Development Application No: DA2025/0448 for Construction of a dwelling house at 100 Hilltop Road AVALON BEACH.

Figure 2: 9am shadow on June 21st

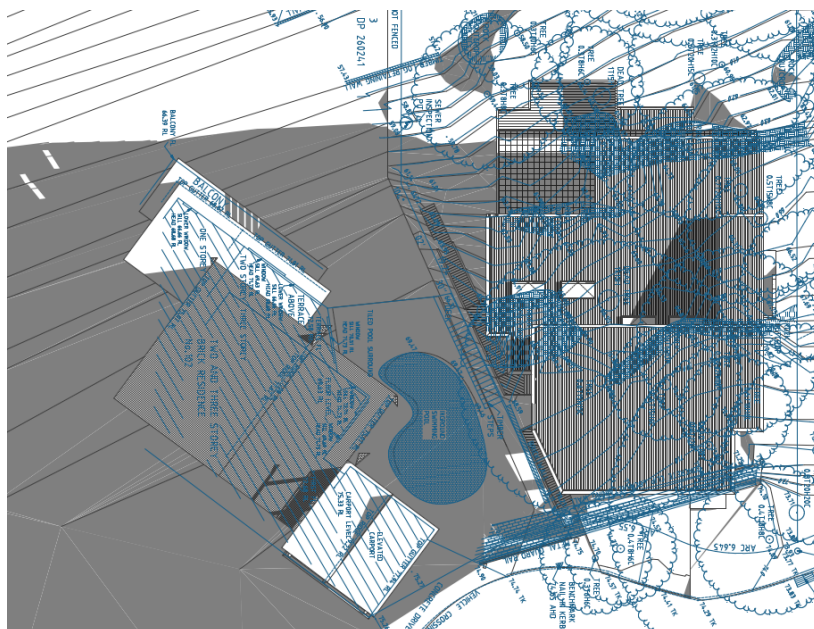
The submitted solar access diagrams indicate that the neighbouring main private open space area, being the pool area, may not receive at least 3 hours of solar access (refer Figures 2-4).

To make a proper assessment of solar access and satisfy the requirements of Section C1.4, further documentation, including solar diagrams at hourly intervals and elevational solar diagrams, shall be provided to depict the impact of the proposed development on the northern aspect of 102 Hilltop Road. The proposed development shall demonstrate that the neighbouring main private open space area achieves at least 3 hours of solar access between 9am and 3pm on June 21st.

Figure 6: *North-eastern elevation*

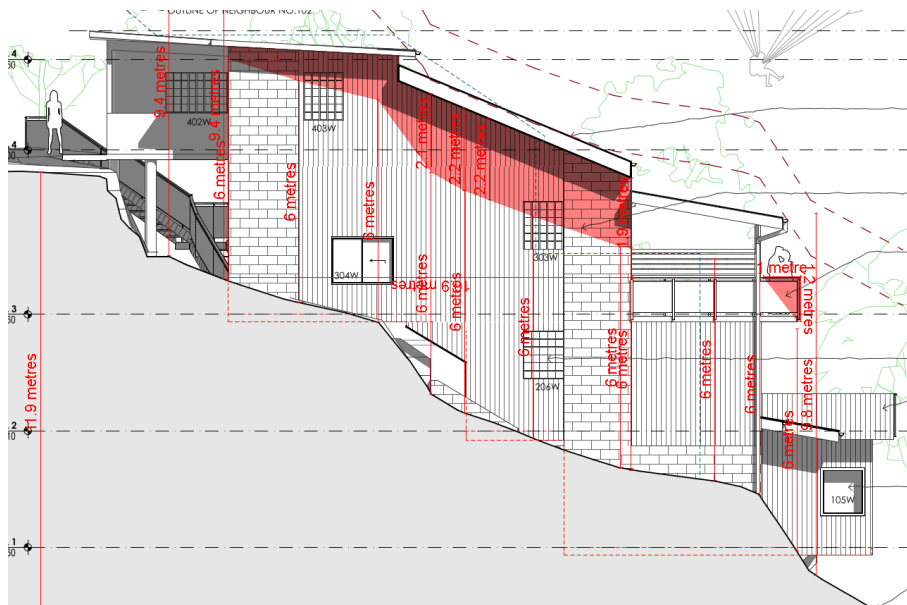
The proposed building envelope at the north-eastern elevation presents an encroachment of between nil and 2.2m in height for a length of 10.9m, and a second encroachment of between nil and 1.2m in height for a length of 1m, resulting in a maximum variation of 36.7% (2.2m), as shown shaded red in Figure 6 below.

The Applicant shall amend the proposed design to reduce the degree of non-compliance with the building envelope, particularly at the south-western elevation. This may be achieved by increasing the side setbacks to the upper levels and reducing the floor-to-ceiling heights. The proposed dwelling has floor-to-floor heights of over 3m and up to almost 4.5m. These heights could be significantly lowered given the minimum floor-to-ceiling height for a habitable room is 2.4m. Importantly, the extent of envelope breach will also be reduced by flipping the assigned setbacks for the development so that the 2.5m requirement applies to the south-western side and the 1m requirement applies to the north-eastern side. Doing so would also allow greater solar access to the property to the south. Notwithstanding compliance with side setback controls, the built form may need to be brought in further from the side boundaries in order to reduce the extent of building envelope breach.

Figure 7: South-western elevation

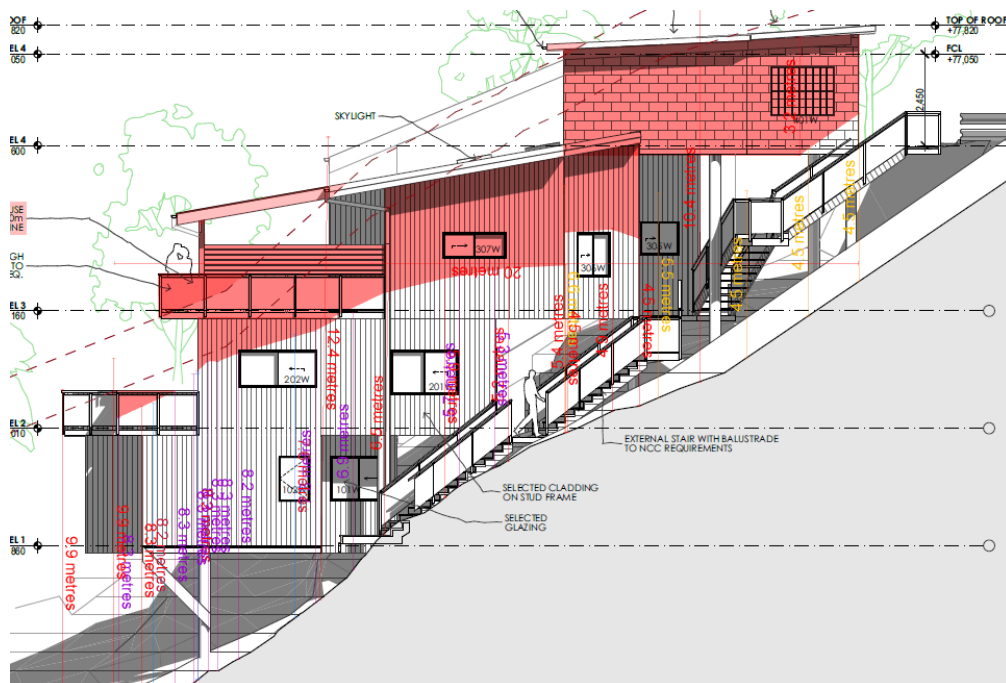
It is recognised that Section D1.11 allows for variation to this control to be considered on a merits basis where the building footprint is situated on a slope over 30%. While the proposed development sits on land with a slope of 61.3%,

the cumulative effect of these non-compliances, particularly in conjunction with the height variation and potential amenity impacts, is a development that is excessive in bulk and scale and considered to be an overdevelopment of the site. Council therefore cannot support such a degree of variation to the building envelope.

Figure 8: Subject site shown in yellow, with example at 159 Riverview Road shown in blue

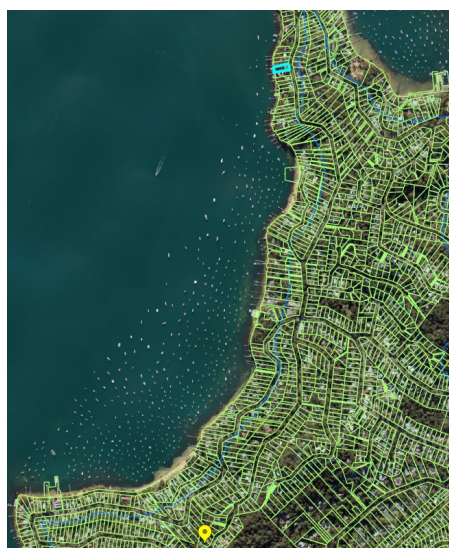
It is acknowledged that photos were provided to Council as examples of other properties with garages having reduced front setbacks; however, the examples provided are located significant distances from the subject site and on different streetscapes (refer Figure 8) and are therefore not comparable.

The garage shall be redesigned such that it be an unenclosed carport so that is a more lightweight structure that is more commensurate with the Hilltop Road streetscape. The parking structure shall also be reduced in size with a small area for bin storage to lower the intrusion of the built form on the streetscape and within the front setback area.
